Access Compliance Report Public Rights-of-Way (Curb Ramps)

Main Street: SANTE_FE_RD Cross Street: VALENCIA_AVE Location: NW

ADA ID: RPAT220218165826 Ramp Type: Type 1 - Perpendicular Diagonal Initial Pass/Fail: Fail Overall Compliance: No Severity Score: 2

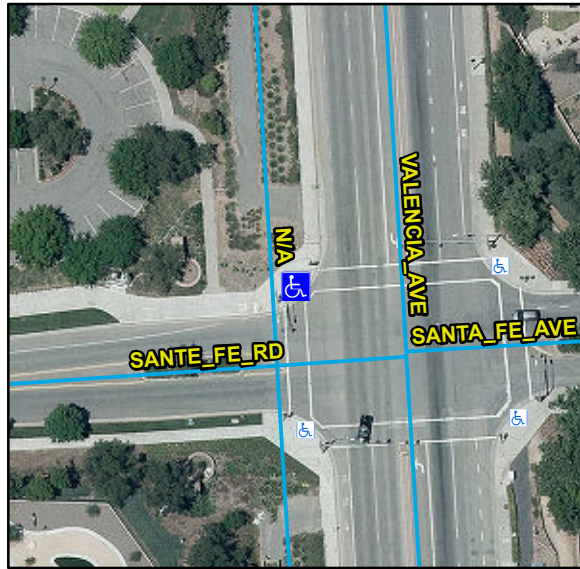
R304.2.2, R304.5.3, STD 1115

Remove & Replace Curb Ramp With Two New Directional Ramps or Equivalent.
